THE SHOP'S AT MERIDIAN RANCH

FILING NO. 1A, LOT 2

PHOTOMETRIC PLAN

Shop's @ Meridian Ranch
Site Development Plan
11810 Stapleton Drive
Falcon, CO

DRAWING NO. **4**
PHOTOMETRIC PLAN

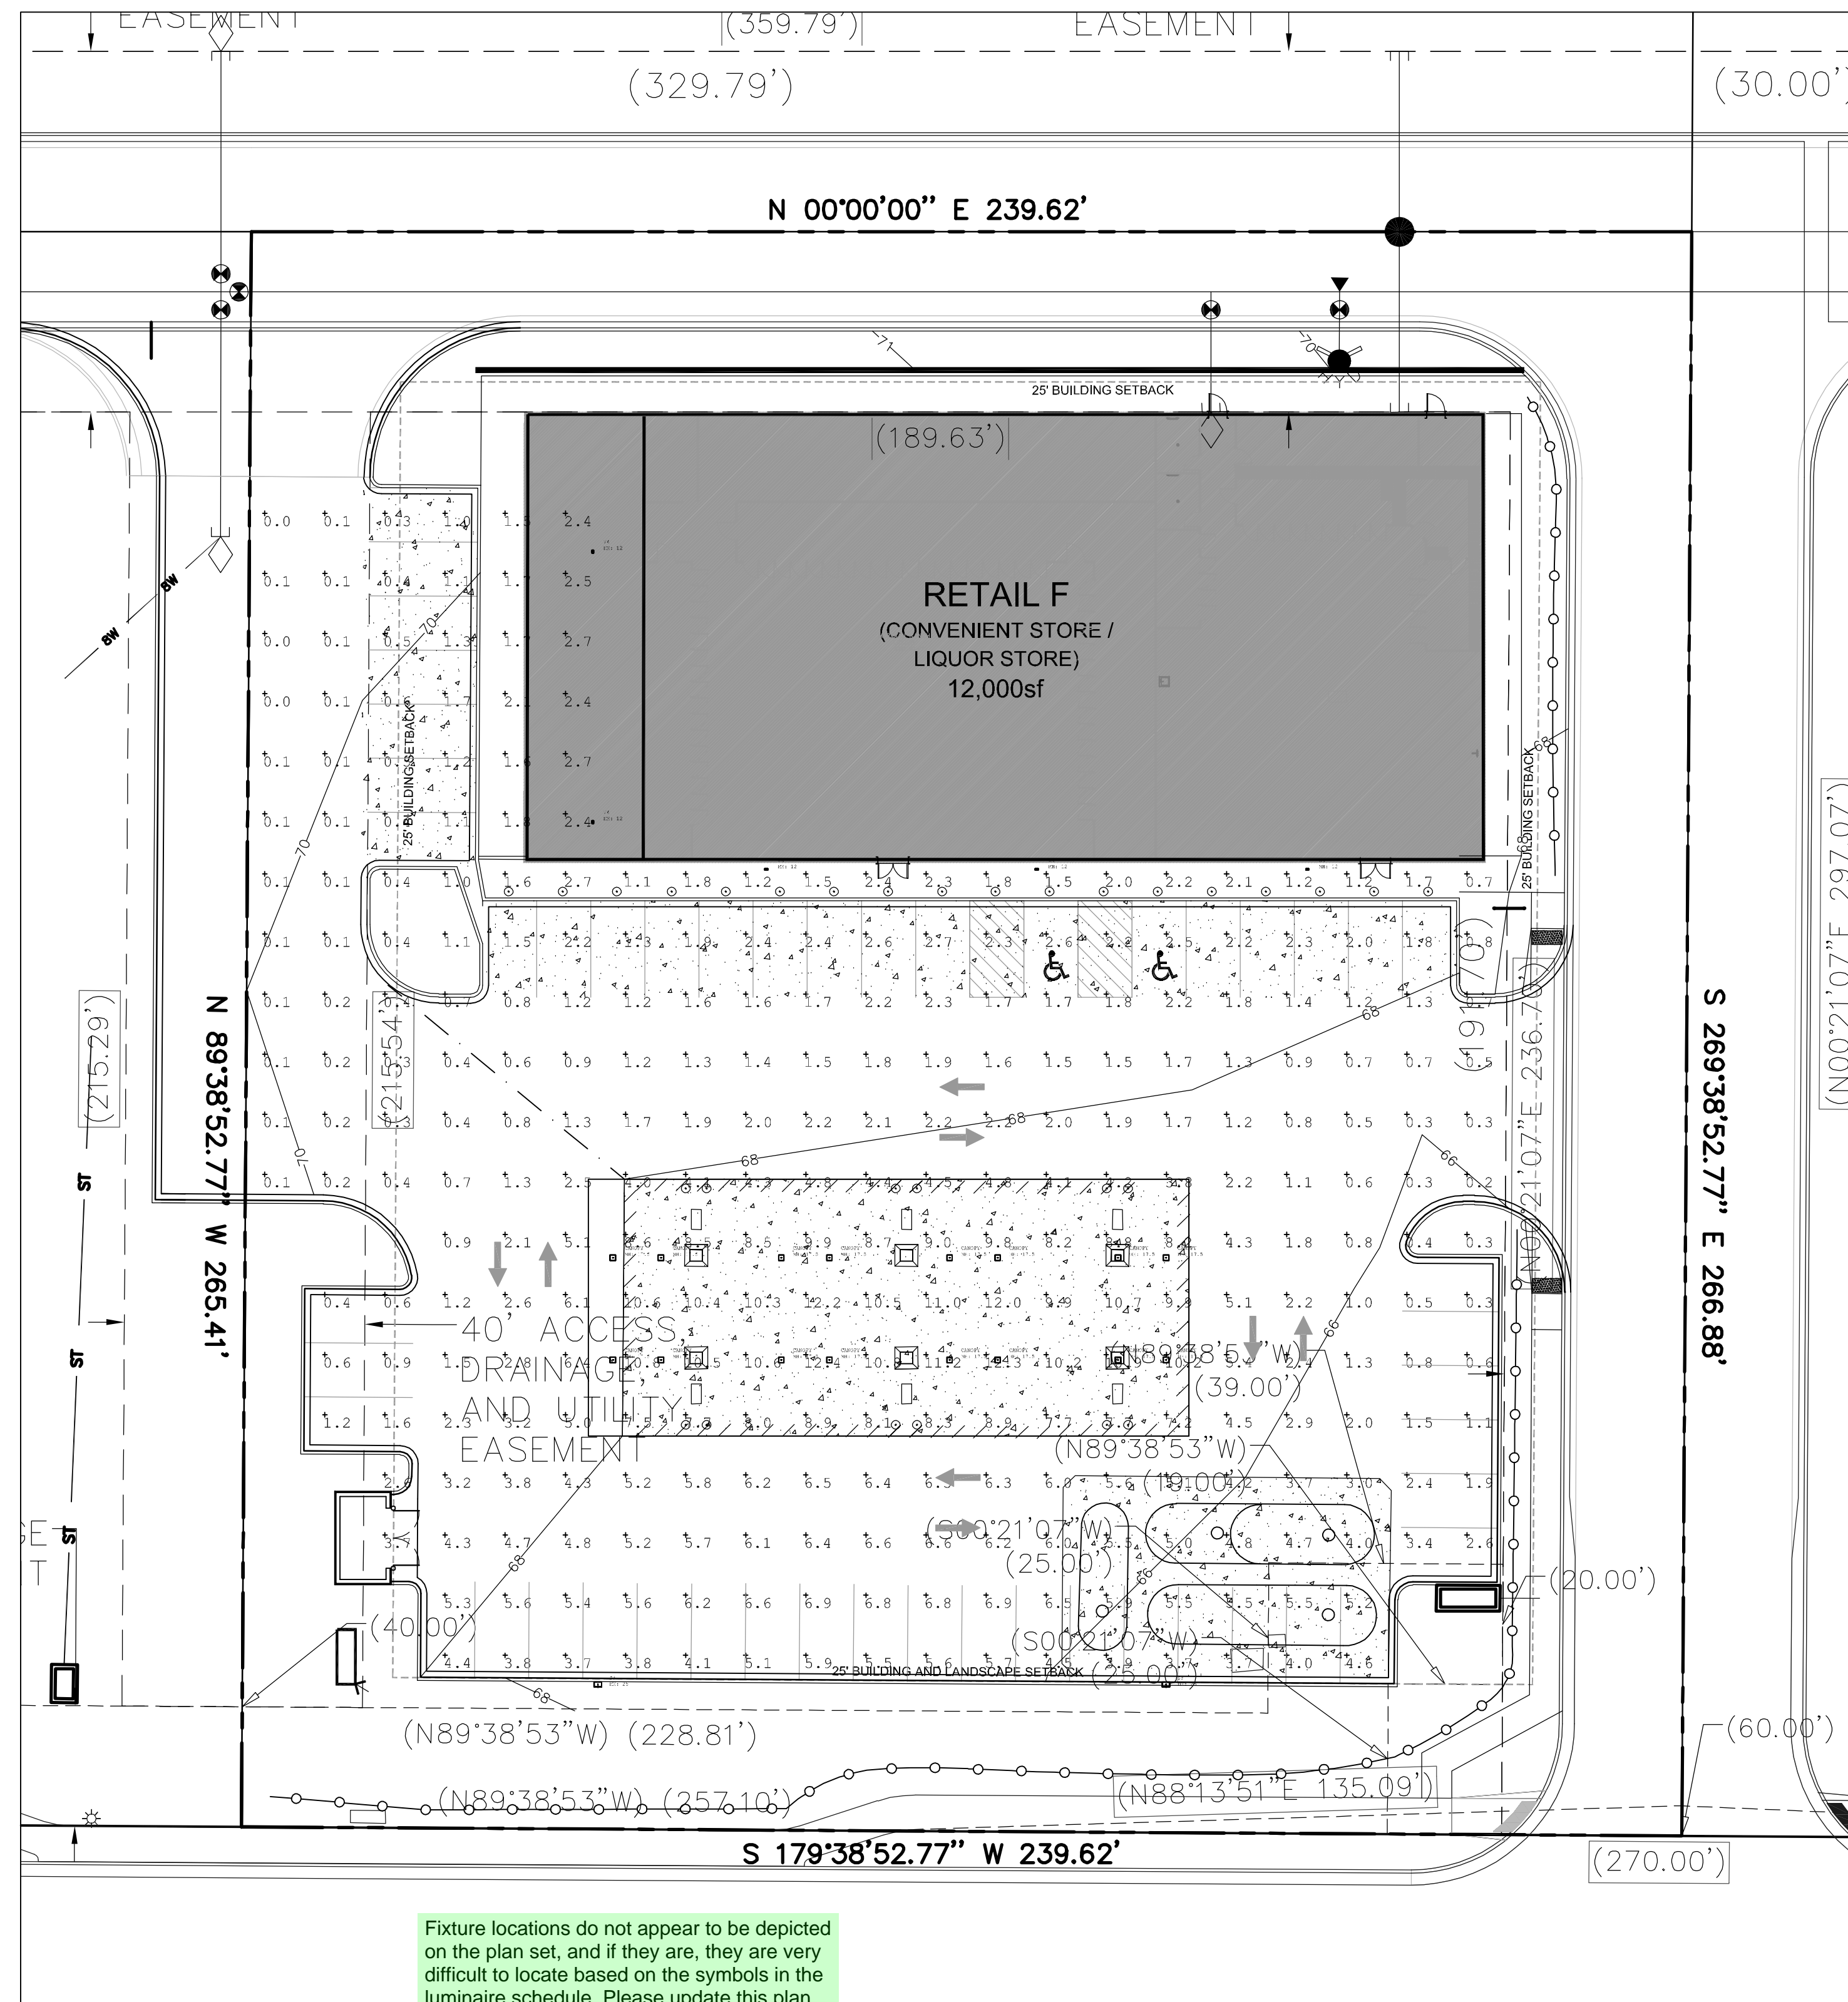
Update the title block to reflect the plat

Fixture locations do not appear to be depicted on the plan set, and if they are, they are very difficult to locate based on the symbols in the luminaire schedule. Please update this plan for clarity.

This lighting plan doesn't provide photometrics for the entire site - it only provides for the parking lot. You need to show that the foot candles are less than 0.1 at property boundaries where adjacent to residential property or public right-of-way (i.e. Stapleton).
